Office Action Summary

10/718,184

DETAILED ACTION

FIG. 7B

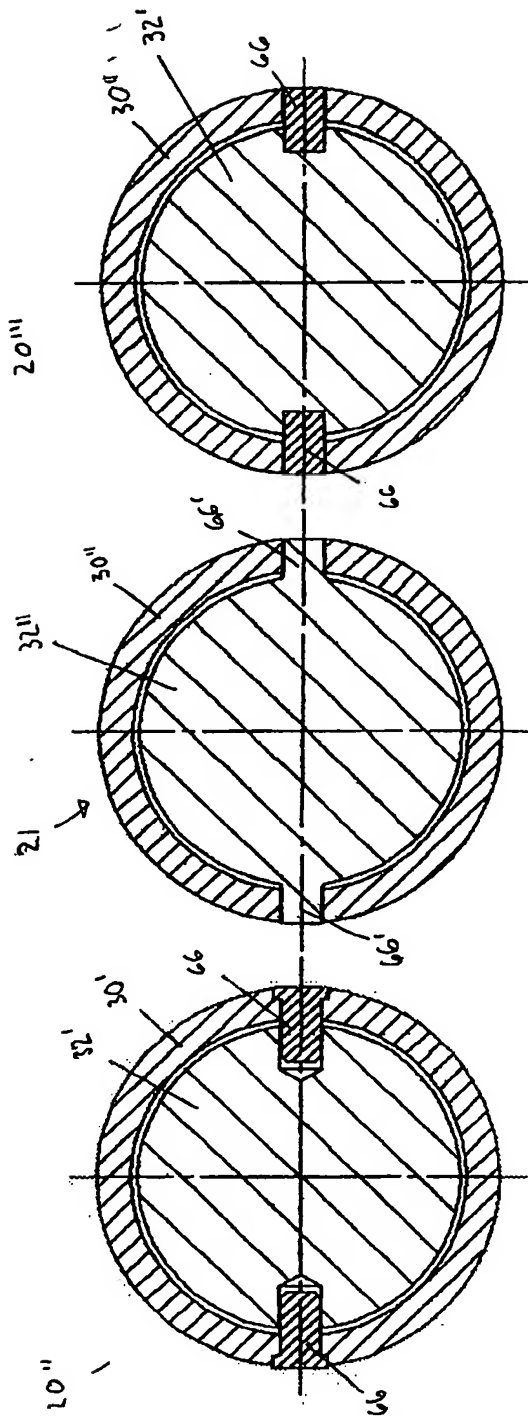
1. The drawings were received on 05/14/2007. These drawings are objected as Fig. 7B illustrates new matter. These drawings have not been entered.

“Specifically, the construction of nozzle 20”, shown in Fig. 7A, represents a transverse, schematic, cross sectional view of the Fig. 7 construction, taken through spray tip 32' at the center line of pivot pins 66. In the Fig. 7C construction of nozzle assembly 20", even though opposed pin members 66 are similarly outwardly directed as in Fig. 7A, pin members 66 are fixedly received in spray tip 32', thereby shifting the rotational interface to shroud 30", while, in Fig. 7A, the rotational interface remains with nozzle tip 32'. *In the Fig. 7B construction, in order to facilitate the assembly of spray tip 32", shroud 30' of Fig. 7A may be split into two cylindrical shell portions 30" (only one being shown) [there is no support for this – the previous paragraph only mentions two semi-cylindrical shells and Fig. 6 appears to show only a cutaway near the pin 66 rather than two cylindrical shells] abutting at pin members 66, each shell portion having opposed cylindrical cutouts in order to accommodate pin members 66. Upon completion of the assembly, the split may be closed via a rotational weld [there is no support for this]. Finally, in the Fig. 7B nozzle construction 21, pin members 66' are preferably **integral** [not supported – the pin*

is only shown as a separate element previously] with spray tip 32", thereby again shifting the rotational interface to shroud 30" which, in order to permit assembly is also comprised of two adjoining cylindrical shell portions 30" in a manner similar to that described relative to Fig. 7C. Thus, the Fig. 7B and 7C constructions are essentially the reverse of the Fig. 7A nozzle construction."

ENTRY
NOT APPROVED

Applicant is required to cancel the new matter in the reply to this Office Action.
